Access Compliance Report

Public Rights-of-Way

Intersection ID: 18776	Main Street: SOUTH_BV	Cross Street: TYVOLA_RD	Location: SE
ADA ID: D048C40D2820	Ramp Type: PerpDiag	Initial Pass/Fail: Fail	Overall Compliance: No
			Severity Score: 21.25

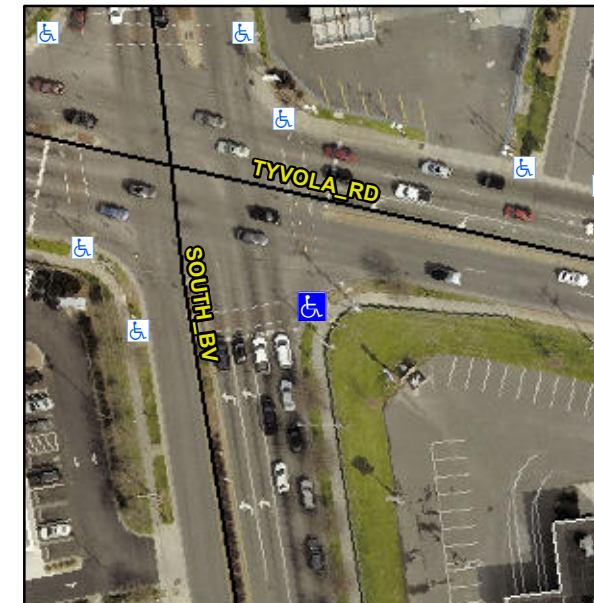
R304.5.1, R304.5.3

Compliance	Description	Data	Compliance	Description	Data
N/A	Ramp Length (in)	73.0	Yes	Ramp Slope (%)	6.8
No	Ramp Width (in)	47.0	No	Ramp XSlope (%)	5.2
N/A	Flare Type LT	N/A	N/A	Flare Type RT	N/A
N/A	Flare Slope LT (%)	N/A	N/A	Flare Slope RT (%)	N/A
N/A	Flare Traversable LT?	N/A	N/A	Flare Traversable RT?	N/A
N/A	Landing Length (in)	N/A	N/A	DWS Provided?	N/A
N/A	Landing Width (in)	N/A	N/A	DWS Contrast?	N/A
N/A	Landing Slope (%)	N/A	N/A	DWS Length (in)	N/A
N/A	Landing X Slope (%)	N/A	N/A	DWS Full Width?	N/A
N/A	Landing Curb? (Y/N)	N/A	N/A	DWS Offset (in)	N/A
N/A	Shared Landing?	N/A			
N/A	Gutter Ponding?	N/A	N/A	Gutter Slope (%)	N/A
N/A	Gutter Lip Ht (in)	N/A	N/A	Gutter X Slope (%)	N/A
N/A	Painted X Walk1?	Yes	N/A	Painted X Walk2?	Yes
	X Walk 1 Direction	To N		X Walk 2 Direction	To W
N/A	X Walk 1 Width (in)	118.0	N/A	X Walk 2 Width (in)	112.0
	X Walk 1 Slope (%)	5.4		X Walk 2 Slope (%)	4.8
	X Walk 1 X Slope (%)	7.5		X Walk 2 X Slope (%)	0.7

Remove & Replace Curb Ramp With Two New Directional Ramps or Equivalent.
